Addenda No. 1

SUBJECT: US101 & OR38: Reedsport to Winchester Bay Paving
Oregon Coast Highway
Douglas County
Grading, Paving & Sidewalks Project
(Bids to be opened and read February 26, 2009)

The following changes are made to the Project Bid Booklet:

OREGON DEPARTMENT OF TRANSPORTATION	
REGION 3 - TECHNICAL CENTER	
US 101 & OR38: REEDSPORT TO WINCHESTER BAY PAVING OREGON COAST HIGHWAY DOUGLAS COUNTY	
Design Team Leader - James P. Burford Designed By - Jered Carpenter Drafted By - Linda K. Coffel	
GENERAL CONSTRUCTION	SHEET NO. 4A

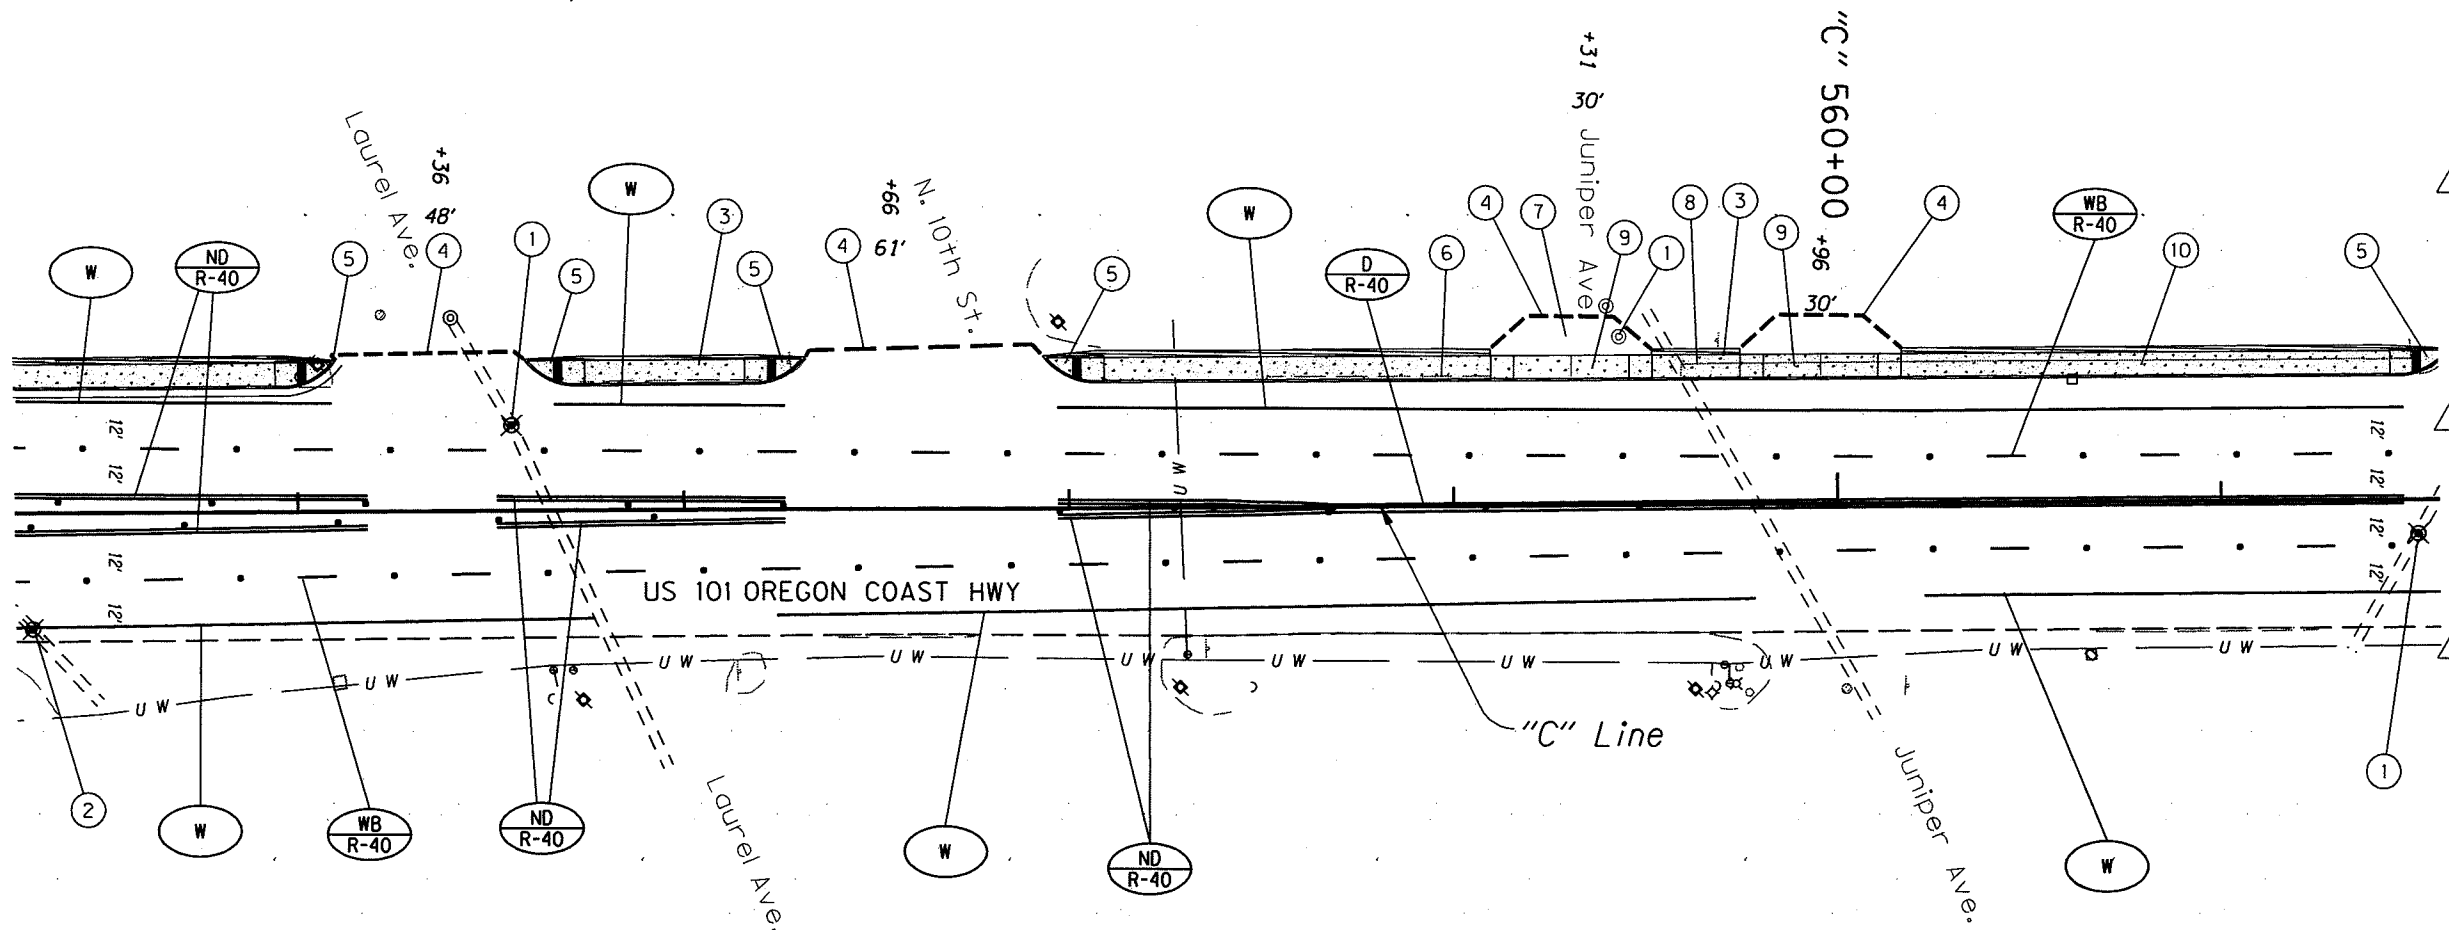
- ④ Sawcut & remove extg. sidewalk ramp - 2
Const. sidewalk ramp (Option 2) - 4
(For details, see sht. 2B-3)
- ⑤ Minor adjust manhole
(See dwg. no. RD360)
- ⚠ ⑥ Const. monolithic curb & sidewalk - 1181.9 sq. ft.
(For details, see sht. 2B-2)

- ⑦ Sta. "C" 554+33.8
Const. P.C. conc. sidewalk to parking lot transition - 49 sq. ft.
(For details see sht. 2B-3)
(See dwg. no. RD735)
- ⚠ ⑧ Const. monolithic curb & sidewalk - 35.4 sq. ft.
E = 7"
(For details, see sht. 2B-2)

- ⚠ ⑨ Const. monolithic curb & sidewalk - 1001.3 sq. ft.
E = 7"
Extra for asphalt slope paving - 373 sq. ft.
(For details, see sht. 2B-2)
- ⑩ Replace signal junction box - 4

Rev. No.	Description	Date	Engineer
⚠ 1	Note addition	2-19-09

SHEET NO. 5

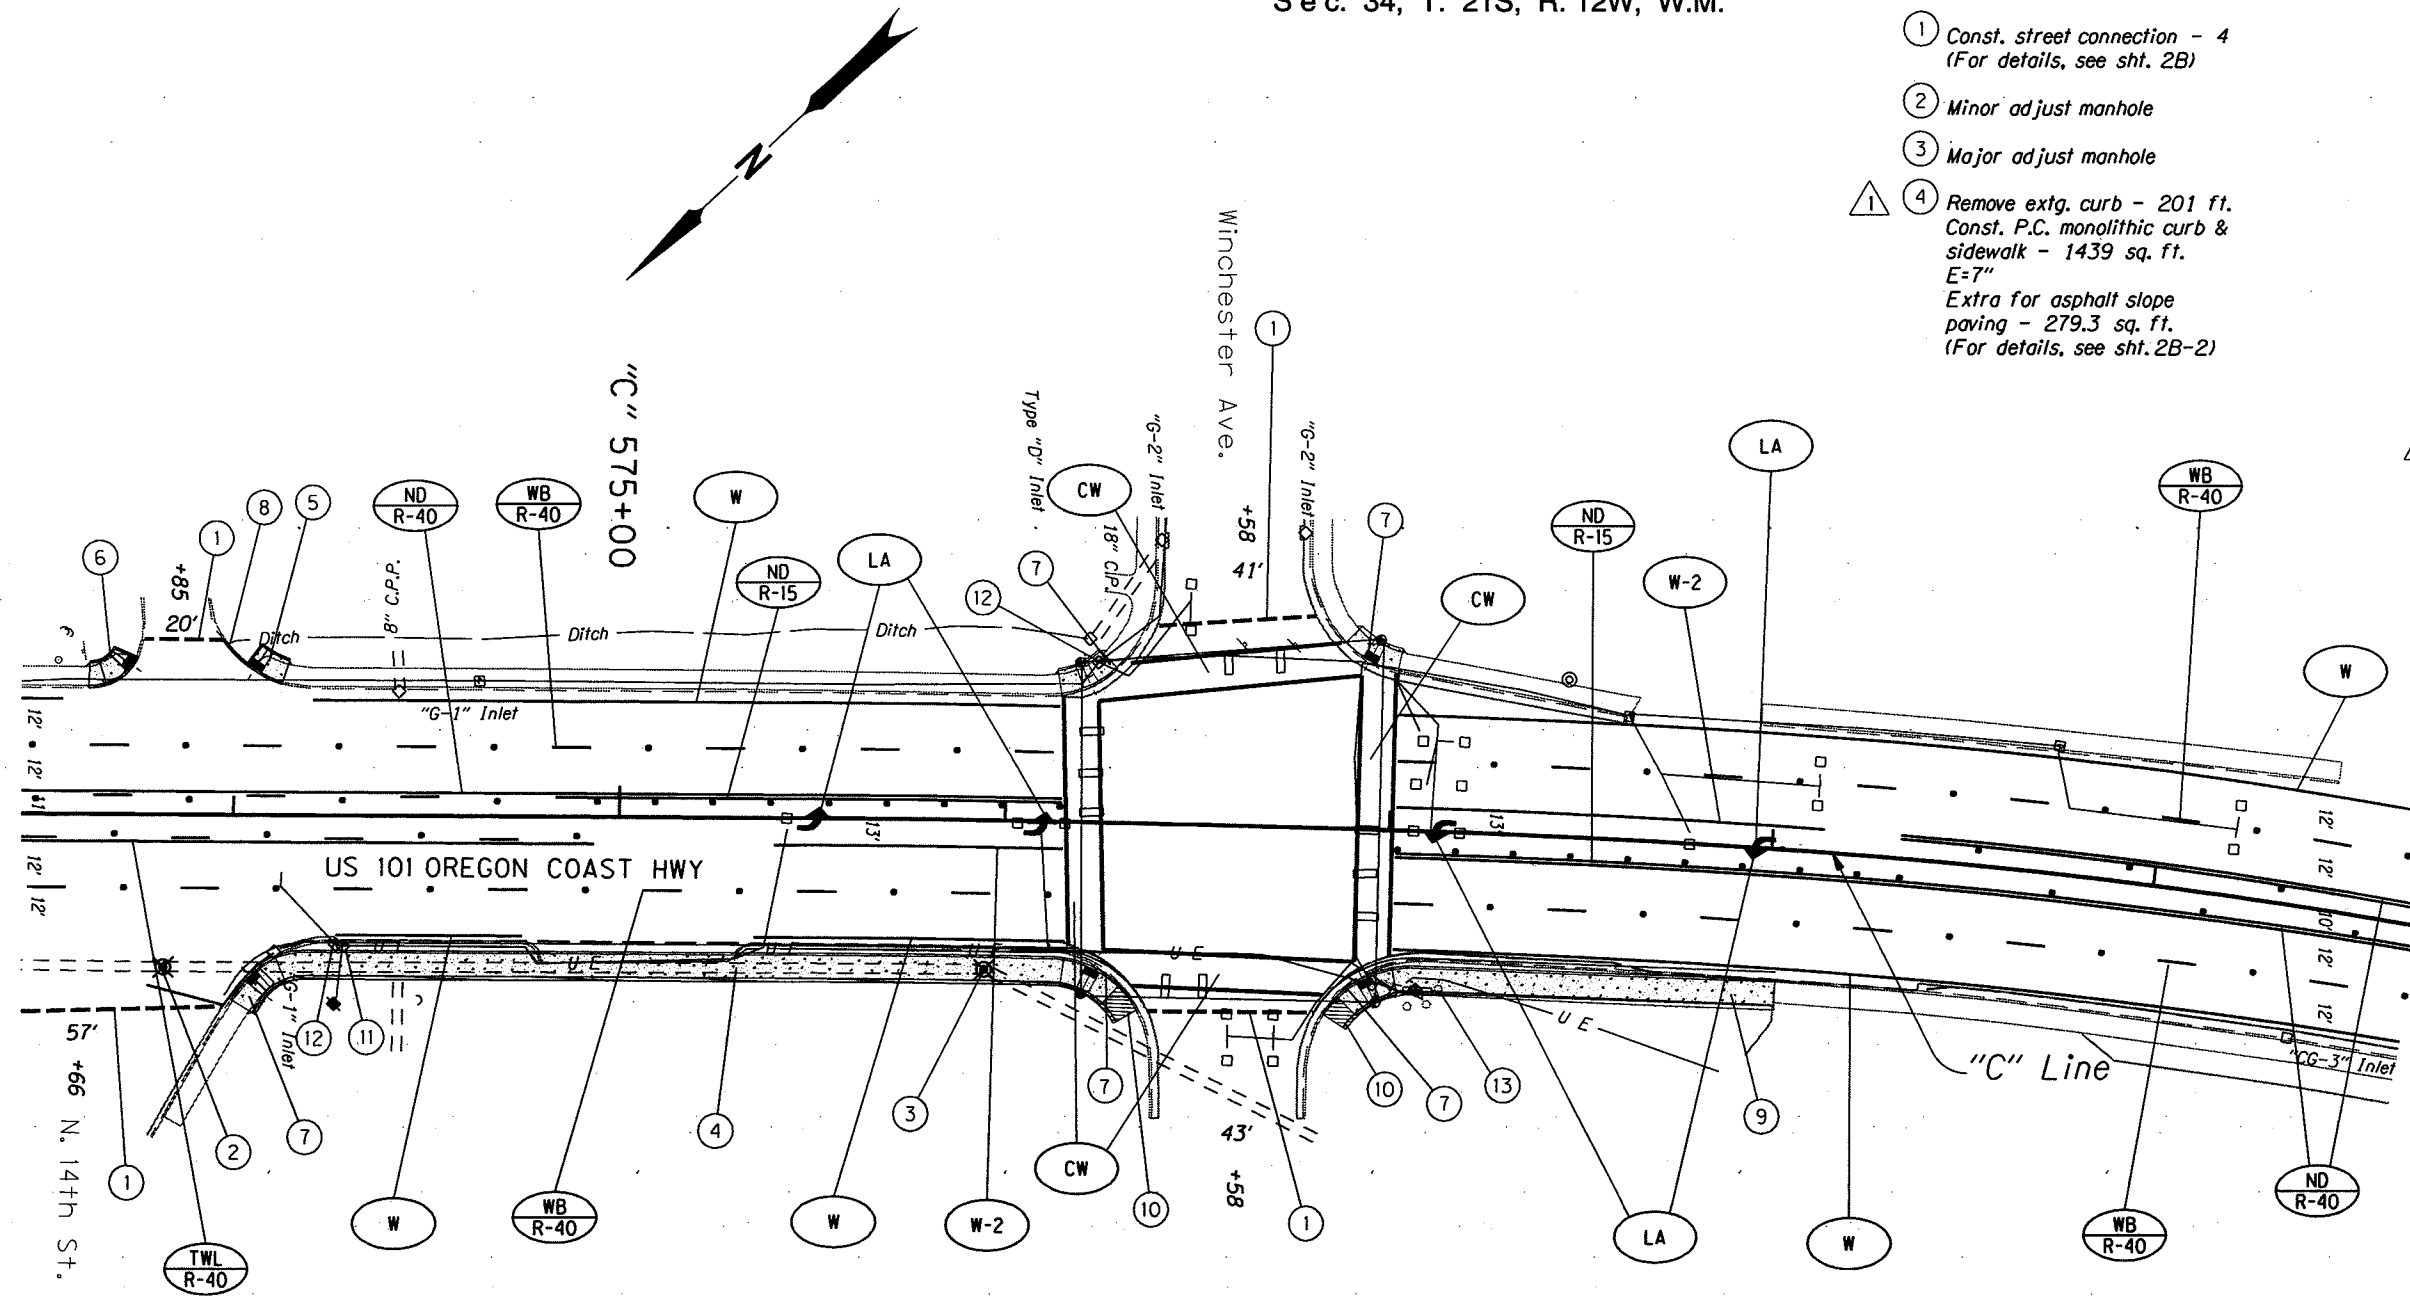
- ① Minor adjust manhole - 3
- ② See sht. 4, note 5
- ③ Remove extg. curb - 59 ft.
Const. monolithic curb & sidewalk - 290.7 sq. ft.
E=7"
Extra for asphalt slope paving - 77.7 sq. ft.
(For details, see sht. 2B-2)

- ④ Const. asphalt apr. - 4
(For details, see sht. 2B)
- ⑤ Const. sidewalk ramp (Option 3) - 5
(For details see sht. 2B-4)
- ⑥ Remove extg. curb - 58 ft.
Const. monolithic curb & sidewalk - 713.9 sq. ft.
E=7"
Extra for asphalt slope paving - 279.6 sq. ft.
(For details, see sht. 2B-2)

- ⑦ Sta. "C" 559+30.8
Const. P.C. conc. driveway (Option G) - 297.5 sq. ft.
(See dwg. no. RD757)
- ⑧ Const. monolithic curb & sidewalk - 162.4 sq. ft.
E= 7"
Extra for asphalt slope paving - 49.5 sq. ft.
(For details, see sht. 2B-2)

- ⑨ Sta. "C" 559+95.7
Const. P.C. conc. driveway (Option G) - 297.5 sq. ft.
- ⑩ Remove extg. curb & sidewalk - 202 ft.
Const. P.C. monolithic curb & sidewalk - 905.1 sq. ft.
E= 7"
Extra for asphalt slope paving - 277.9 sq. ft.
(For details, see sht. 2B-2)

Rev. No.	Description	Date	Engineer
①	Note addition	2-19-09	B

SHEET NO.
8

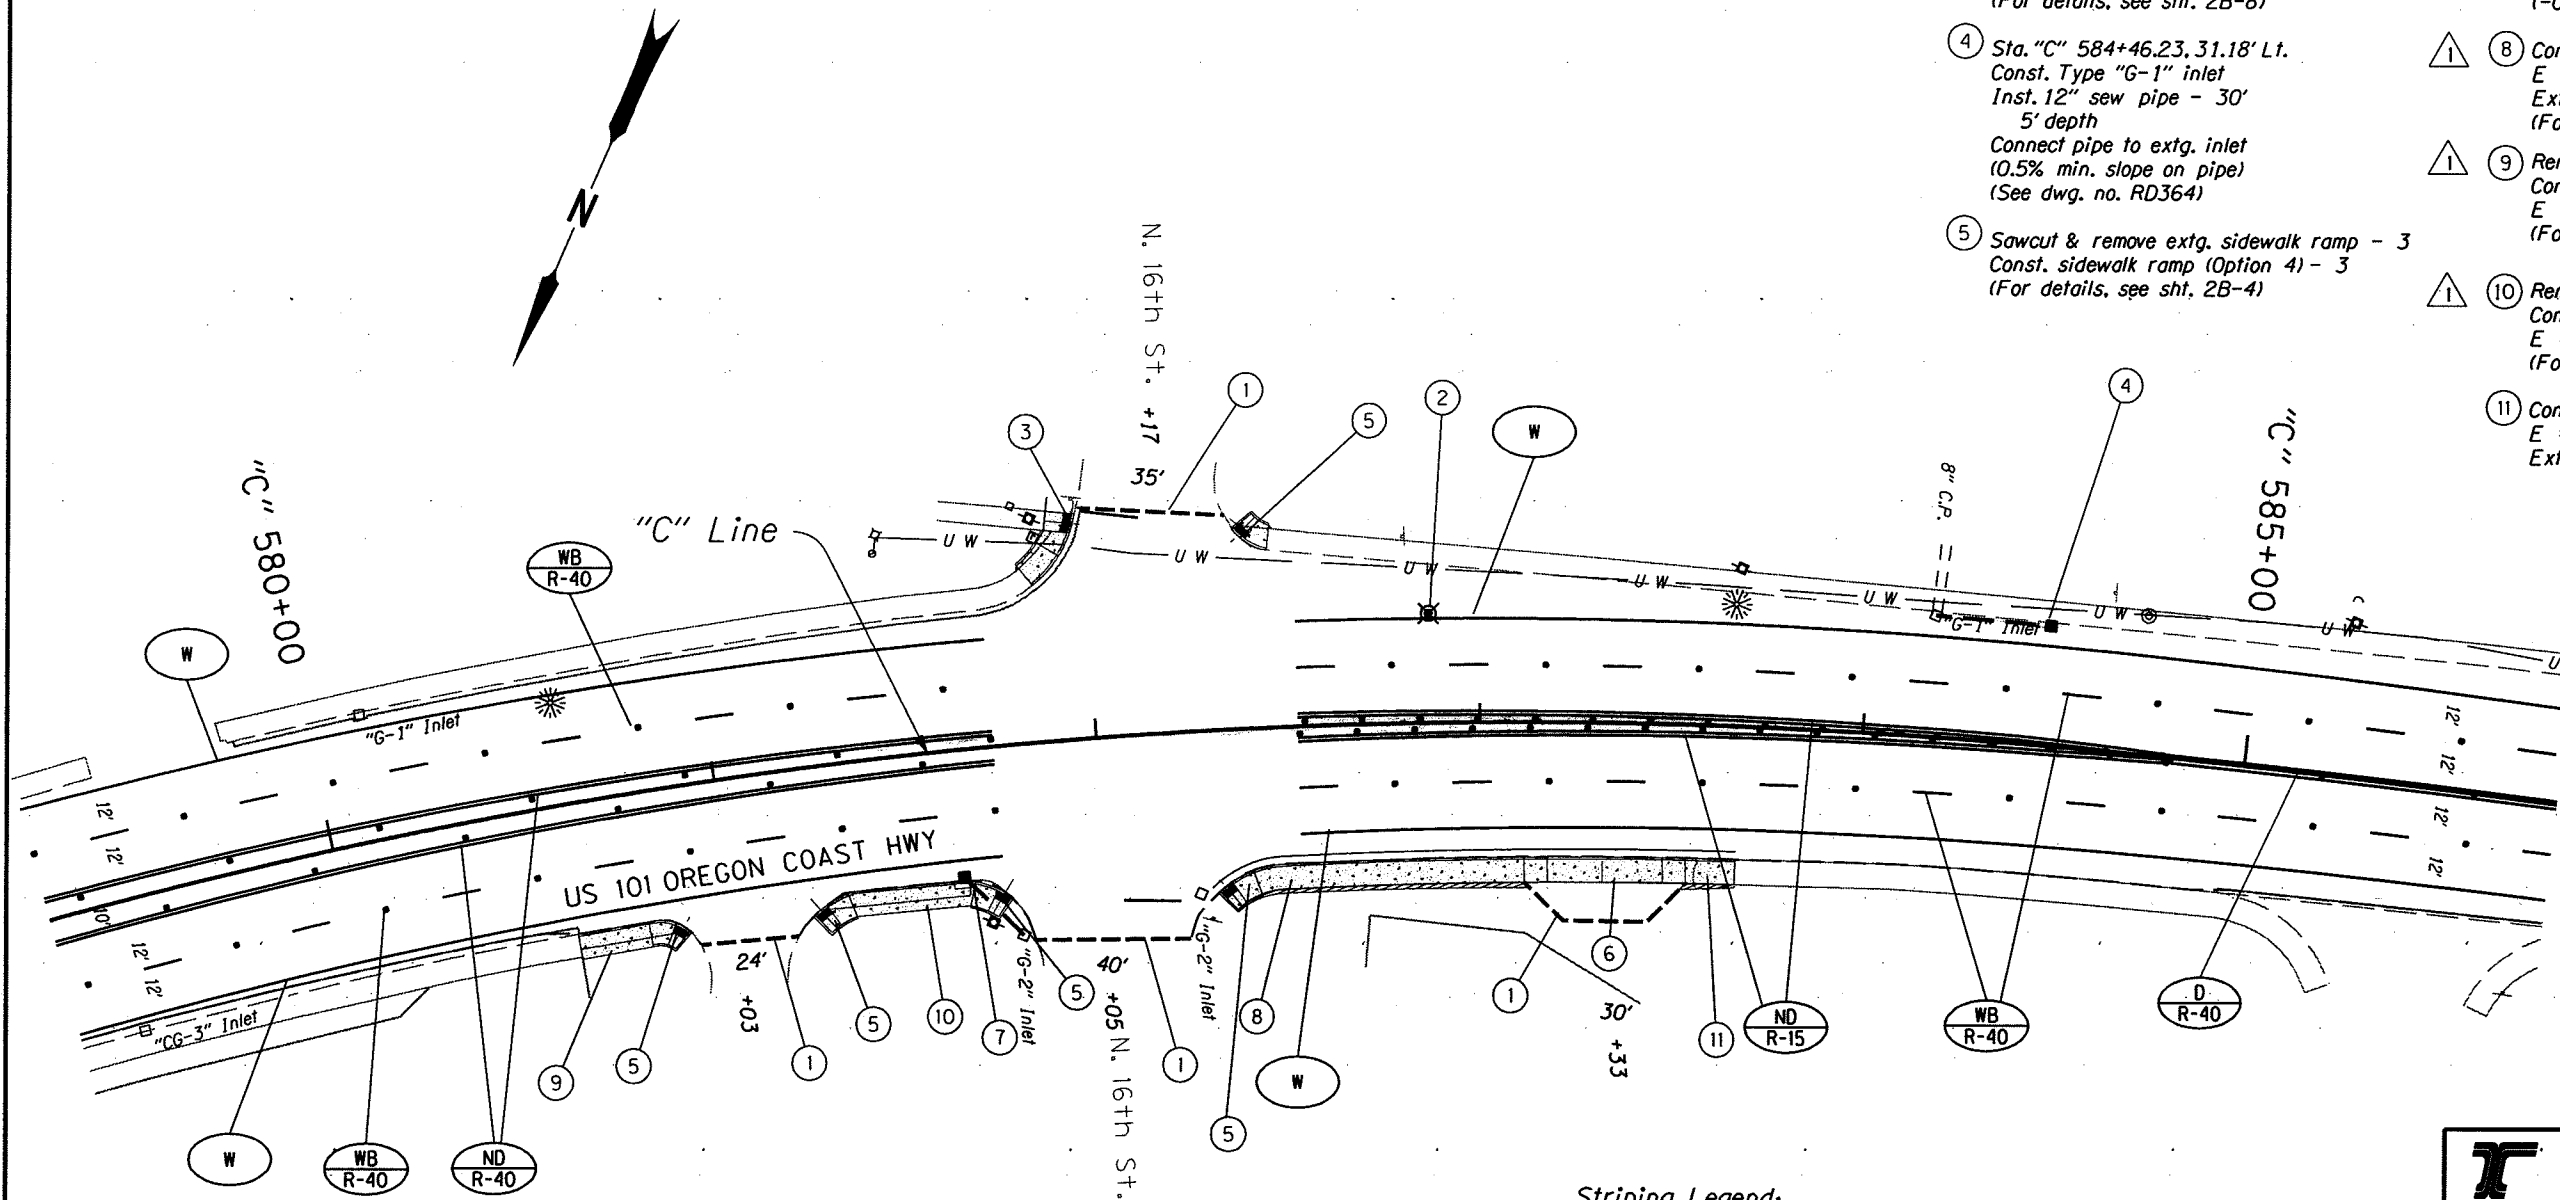
- ① Const. street connection - 4
(For details, see sht. 2B)
- ② Minor adjust manhole
- ③ Major adjust manhole
- ⚠ ④ Remove extg. curb - 201 ft.
Const. P.C. monolithic curb & sidewalk - 1439 sq. ft.
E=7"
Extra for asphalt slope paving - 279.3 sq. ft.
(For details, see sht. 2B-2)

- ⚠ ⑨ Remove extg. curb - 123 ft.
Const. monolithic curb & sidewalk - 665.0 sq. ft.
E= 7"
Extra for slope paving - 173.4 sq. ft.
(For details, see sht. 2B-2)
